STATE OF NORTH CAROLINA
DEPARTMENT OF TRANSPORTATION

Subject: Request for Modification to Individual Section 404 and 401 permits, CAMA Major Development Permit, and Tar-Pamlico Riparian Buffer Authorization for the proposed Washington Bypass. US 17 from North of SR 1509 (Springs Road) to North of SR 1418 (Roberson Road). TIP Number: R-2510C, Federal Aid Project MAF-75-3(26). Debit \$570 from WBS Element No. 34440.1.1.

The purpose of this document is to submit a modification request for the Clean Water Act (CWA) Section 404 Individual Permit and Section 401 Water Quality Certification, Tar-Pam Riparian Buffer Authorization, and the CAMA Major Permit. An additional permit drawing/buffer drawing is included in this modification request.

Permit Drawing
Sheet 32A of 42

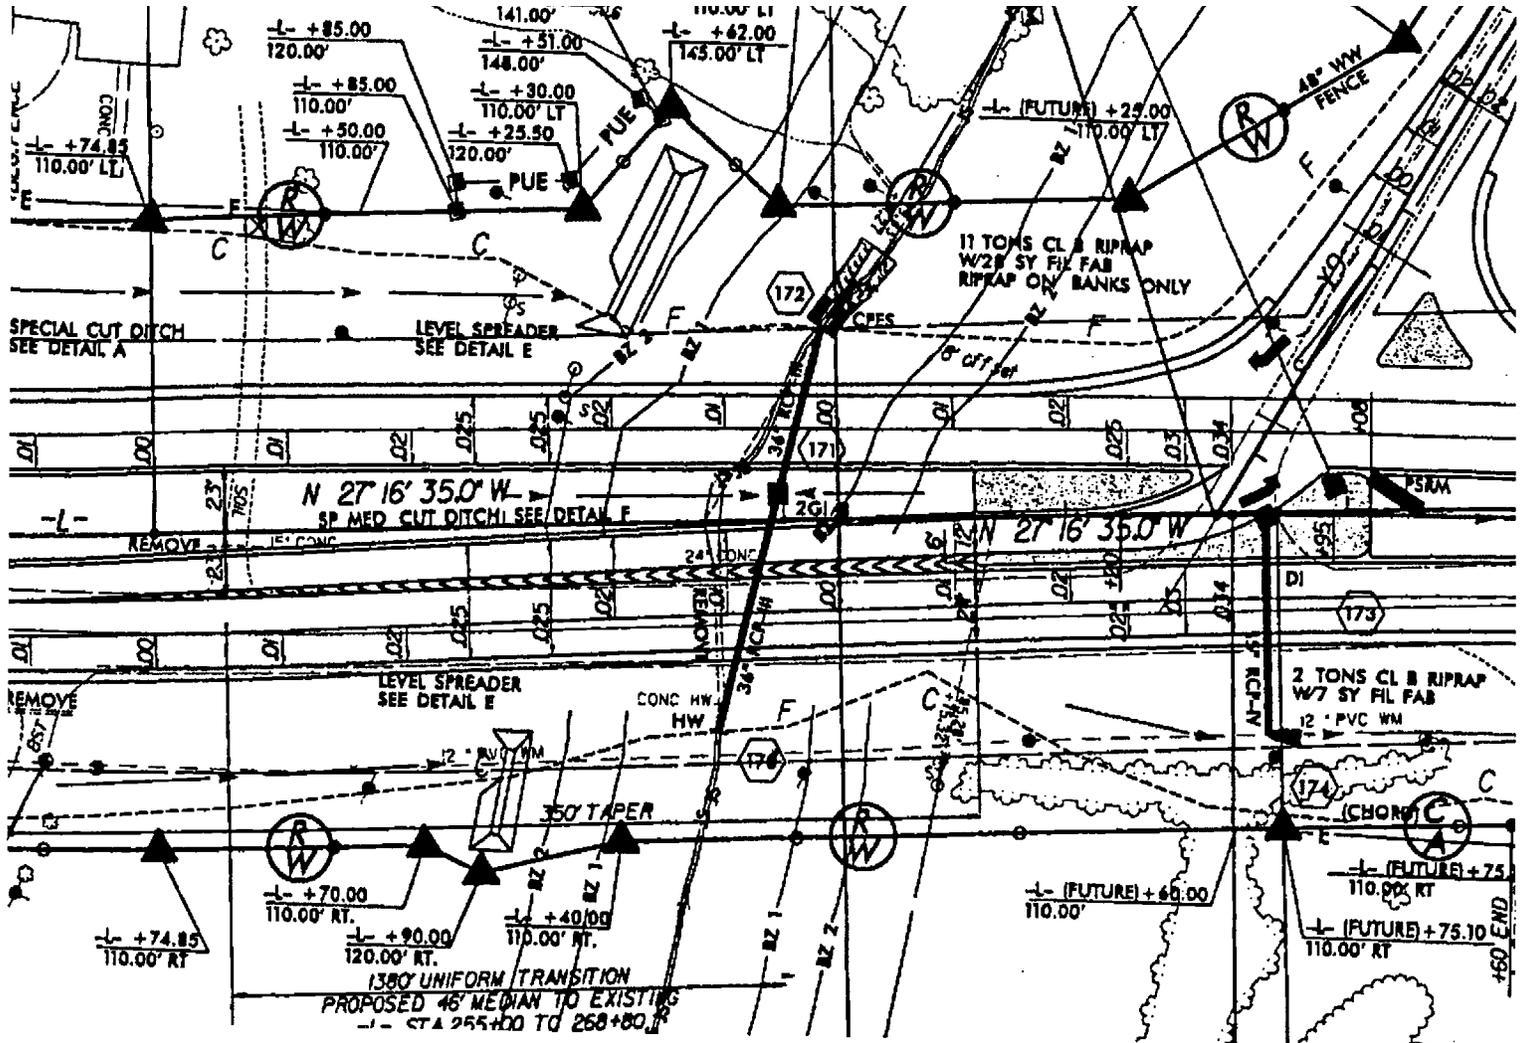
Additional buffer and stream impacts will result due to the need to realign pipe structure # 172 at Station 257+00 +/- with the existing jurisdictional stream. After discussion with the contractor, looking at future maintenance issues and long term stream impacts, we propose to remove the flared end section, construct a drainage structure including frame & grate, grade this area to drain to the grate, install additional pipe from the drainage structure to the 30 feet clear zone, and to place Class "B" rip rap at the outlet of the pipe. This would require additional buffer impacts of 25 feet long by 10 feet wide for a total of 250 sq.ft. (Zone 1 only). This would also require an additional 10 linear feet of stream impacts to pipe this area.

10 Linear Feet of the stream surface water would be impacted by piping 10' additional with a 36" RCP Class III pipe. There would be additional BZ1 impacts due to shaping eroded stream bank to a 2:1 slope and lining with Class B Rip Rap.
